A380 Telegraph Hill – removal of slip lane

Report of the Head of Planning, Transportation and Environment

ENV ID 5329:
Devon County DCC (A380 Telegraph Hill Offside Link)
(Prohibition of Motor Vehicles) Order

Drawing number: A12003/011B

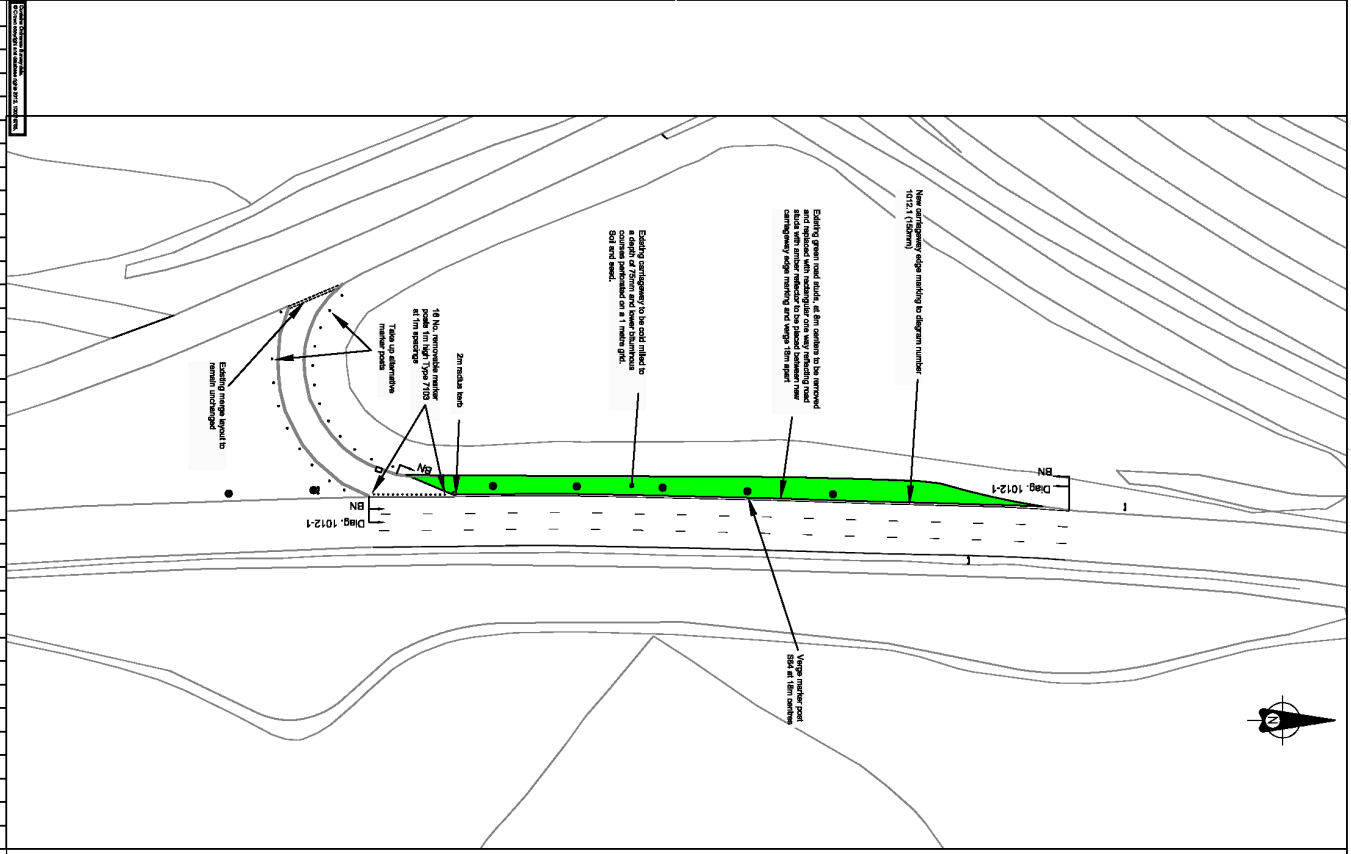
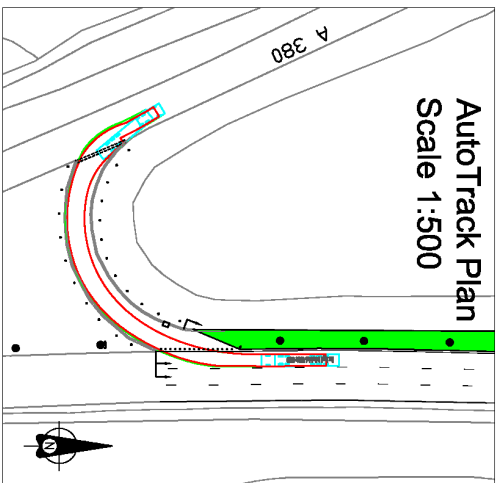
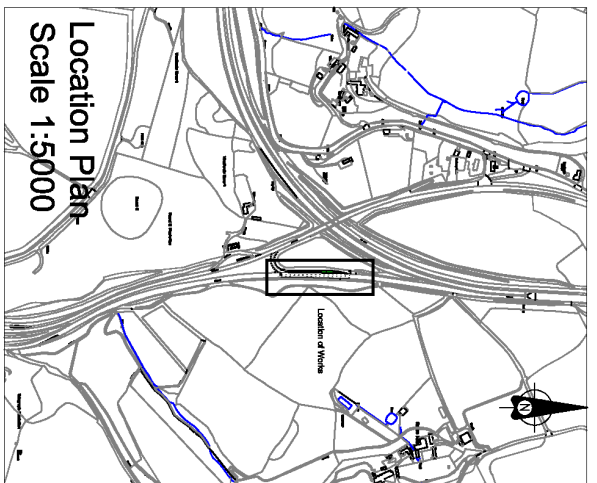
Resident of/Owner or user of nearby premises	Objection Comments	DCC Response
1	Haldon Hill	<p>Supports retaining the link loop as it is a really useful short cut back down the hill.</p> <p>Been using the link loop for the past five years with no problems. Alternative route is a considerable detour.</p> <p>A speed restriction descending Telegraph Hill would be a far better precautionary measure.</p>	<p>It is accepted that the link will increase journey time and distance for regular users on the southbound leg of their journey. However, this needs to be balanced against the risk of use for all motorists and not just local traffic.</p> <p>Non-local traffic is over-represented in the collision history and 50% of the surveyed vehicles using the crossover did not use it to access residences or premises on Old Haldon Hill.</p> <p>A Telegraph Hill speed restriction is not within the scope of this proposal and would represent significant compliance and enforcement challenges. Non-compliance would also increase the risk to traffic emerging from the crossover northbound.</p>

2	Haldon Hill	<p>Not aware of Devon County Councils (DCC) intention to close the short road that links the northbound and southbound sides of Telegraph Hill.</p> <p>Been using the Telegraph Hill for over 43 years on a daily basis and have yet to witness any incident related to this road on either the uphill deceleration slip lane or on the exit onto the downhill side of Telegraph Hill.</p> <p>Alternative route adds a considerable distance to homeward journey and is more dangerous to use as the deceleration lane at the top of the Telegraph Hill is very short and on a section that is only two lanes wide creating a potential accident spot.</p> <p>If it is DCC case that a junction onto a major road is dangerous then they would have to close hundreds of other junctions, many which are a lot worse than this one.</p> <p>If DCC want to make the road safer maybe signs warning motorists of the</p>	<p>Advertisement of the order was fully compliant with our statutory obligations and the extended consultation period provided further opportunity for comment.</p> <p>Collision histories have been supplied by Devon and Cornwall Police and verified by Devon County Council.</p> <p>It is accepted that the alternative route is longer. However, Haldon Chalets offers a more contemporary and safer design that is reflected in an improved and superior collision history since its inception in 2006.</p> <p>Each casualty and severity reduction site is considered on its merits and solutions are sought that are best suited to the location and its context.</p> <p>Additional signing may have the effect of increasing the use of the route which,</p>

4	Kennford	<p>Objects to the proposed prohibition of motor vehicles on the A380 Telegraph Hill Offside Link.</p> <p>Little consideration given to those who live on Old Haldon Hill who will have to travel greater distances to be able to reach their homes.</p> <p>With the severe winter weather conditions increasing over the last few years, roads have been impassable and if the severe conditions continue then the residents will be unable to get home as the only way they will be able to get home is to travel all the way to the top of the hill which will be impossible.</p>	<p>It is accepted that the link will increase journey time and distance for regular users on the southbound leg of their journey. However, this needs to be balanced against the risk of use for all motorists and not just local traffic.</p> <p>The traffic order that comes with the closure of the crossover explicitly allows for its use for winter maintenance and traffic management purposes as required. It will therefore be possible to open the crossover to managed traffic in extreme weather conditions if necessary.</p>

Resident of/Owner or user of nearby premises	Objection Comments	DCC Response
5	Old Haldon Hill	<p>Strongly objects to the proposed closure of the offside link.</p> <p>Considerable miles and time will be added to journeys to take children to school and other club activities. These journeys are unavoidable and the additional costs to travel are unreasonable.</p> <p>Not witnessed or been aware of any incidents due to this road.</p> <p>Proposed route is much more dangerous, as pulling out at the top of the hill with limited view is far more hazardous. The area is renowned for adverse weather conditions including thick fog. Visibility becomes very limited and unsafe potentially causing more accidents and putting family at increased risk.</p>	<p>It is accepted that the link will increase journey time and distance for regular users on the southbound leg of their journey. However, this needs to be balanced against the risk of use for all motorists and not just local traffic.</p> <p>Collision histories have been supplied by Devon and Cornwall Police and verified by Devon County Council.</p> <p>Haldon Chalets is a more contemporary and safer design and this is reflected in its collision history. The design of the crossover is especially hazardous in limited visibility, as traffic in the fastest lanes south and northbound will encounter unexpectedly slower moving vehicles accessing or leaving the crossover.</p>

6	Haldon Hill	<p>Objects to proposal and believes it should be scrapped.</p> <p>Closure of link road will add considerable time and expenditure to journeys as a result of having to use the alternative route.</p> <p>Disagrees with statement of reasons – to improve road safety and reduce the number of collisions. Not been aware of any accidents arising from the use of the link road.</p> <p>Visibility is not obscured in any way when joining the carriageway from the link road as you have sight of all the traffic approaching.</p> <p>Slip road for Kenn & Kennford is far more hazardous to exit than the Telegraph Hill link road.</p> <p>If proposal goes ahead, it shows a blatant disregard for residents of Haldon Hill and Deer Park Business Centre.</p>	<p>It is accepted that the link will increase journey time and distance for regular users on the southbound leg of their journey. However, this needs to be balanced against the risk of use for all motorists and not just local traffic.</p> <p>Collision histories have been supplied by Devon and Cornwall Police and verified by Devon County Council.</p> <p>The design requires vehicles exiting the crossover northbound to enter, usually from a state of rest, the overtaking lane on an extended downhill section of a high speed route. This is not considered an acceptable design by contemporary standards.</p> <p>Kenn is not being proposed as an alternative route.</p> <p>The proposal has considered the additional journey time and distance for southbound traffic and this has been balanced against the safety benefits of closure applicable to all motorists on this section of the A380.</p>

Resident of/Owner or user of nearby premises	Objection Comments	DCC Response
7	Old Haldon Hill	<p>Lived in area for many years and yet to see any accidents at the link road. More dangerous spots including the lay-by just above the link road and the slip road from Kennford.</p> <p>Proposed diversion route is not a minor diversion and will add extra 1.8 miles to each journey which will add time and money. Joining the road at the top of Telegraph Hill is dangerous as there is a very short access and visibility is poor.</p> <p>The link road is far from redundant and it is used by residents, delivery drivers, employees, friends and other visitors.</p>	<p>Collision histories have been supplied by Devon and Cornwall Police and verified by Devon County Council.</p> <p>It is accepted that the link will increase journey time and distance for regular users on the southbound leg of their journey. However, this needs to be balanced against the risk of use for all motorists and not just local traffic. Haldon Chalets is safer design and this is reflected in the improved collision in recent years.</p> <p>It is accepted that the crossover is in use. However, surveys indicate that vehicle flow averages are 47 movements per day, of which 50% accesses Old Haldon Hill premises and residences and the remainder return north towards Exeter.</p>

8	Rockbeare, Exeter	<p>Been using the link road since 1982, not witnessed any accidents, near misses or other road safety issues at the A380 link or its slip road.</p> <p>The access link has wonderful visibility in respect of approaching traffic and there is nothing to prevent drivers from joining the carriageway in perfect safety. The layout presents no more risk than any other junction with first class visibility.</p> <p>The alternative route offered will increase a journey by two miles to access a point 50yds away. Has DCC's carbon emissions programme been discontinued?</p> <p>The alternative route is hazardous and those using the alternative route would have difficulty particularly in bad weather and at night and would be exposed to more harm than at the existing access.</p>	<p>Collision histories have been supplied by Devon and Cornwall Police and verified by Devon County Council.</p> <p>The design requires vehicles exiting the crossover northbound to enter, usually from a state of rest, the overtaking lane on an extended downhill section of a high speed route. This is not considered an acceptable design by contemporary standards.</p> <p>It is accepted that the link will increase journey time and distance for regular users on the southbound leg of their journey. However, this needs to be balanced against the risk of use for all motorists and not just local traffic and the number of journeys affected are relatively few.</p> <p>Haldon Chalets is safer design and this is reflected in the improved collision in recent years. In poor weather and at other times of reduced visibility the crossover is considered particularly hazardous because it requires slower moving vehicles to use the overtaking lanes south and northbound.</p>

Resident of/Owner or user of nearby premises	Objection Comments	DCC Response
		<p>Deceleration lane is not 'redundant' as it is in regular daily use by the community and remains the only practical access from the North.</p> <p>The proposed detour route is potentially dangerous as there are five junctions to negotiate before starting back down Old Haldon Hill. The route is complicated and would be confusing for visitors and there would be an increase of risk for those travelling in bad weather conditions.</p>	<p>It is accepted that the crossover is in use. However, surveys indicate that vehicle flow averages are 47 movements per day, of which 50% access Old Haldon Hill premises and residences and the remainder return north towards Exeter.</p> <p>Haldon Chalets is safer design and this is reflected in the improved collision in recent years. In poor weather and at other times of reduced visibility the crossover is considered particularly hazardous because it requires slower moving vehicles to use the overtaking lanes south and northbound.</p>

11	Old Haldon Hill	<p>Objects to Prohibition of Motor Vehicles Order.</p> <p>Have not seen or heard of a collision on the slip road since using it for over ten years whereas DCC collision data report states 8 collisions have occurred in a four year period.</p> <p>Witnessed more accidents on the southbound carriageway at the top of Telegraph Hill.</p> <p>On analysing the collision data, the descriptions of locations are described incorrectly and therefore the traffic collision data has not been recorded accurately and the validation procedures are not vigorous enough. The whole basis upon which DCC is closing the slip road is founded on false data.</p>	<p>Collision histories have been supplied by Devon and Cornwall Police and verified by Devon County Council.</p> <p>Haldon Chalets junctions do not have a comparable collision history.</p> <p>The geographical locations of the recorded collisions are correct. There are sometimes mismatches between the Easting/Northing supplied by the police and the officer's description of the location. This is common and reconciled during our data verification process, which also uses the incident/manoeuvre descriptions to ensure the location is correctly plotted.</p>

Attached plan no. A12003/001B shows the proposed scheme, which involves the removal of the uphill deceleration lane and the closure of the crossover to regular traffic.

The crossover itself will remain as it may still be required for winter maintenance operations and for police emergency and traffic management use in the event of road closures. Right of access would be retained by **all** blue light services in emergency situations. In order to prevent unauthorised use, access to the lane will be controlled by means of a line of removable traffic cylinders. A traffic regulation order will be required to enforce the restrictions.
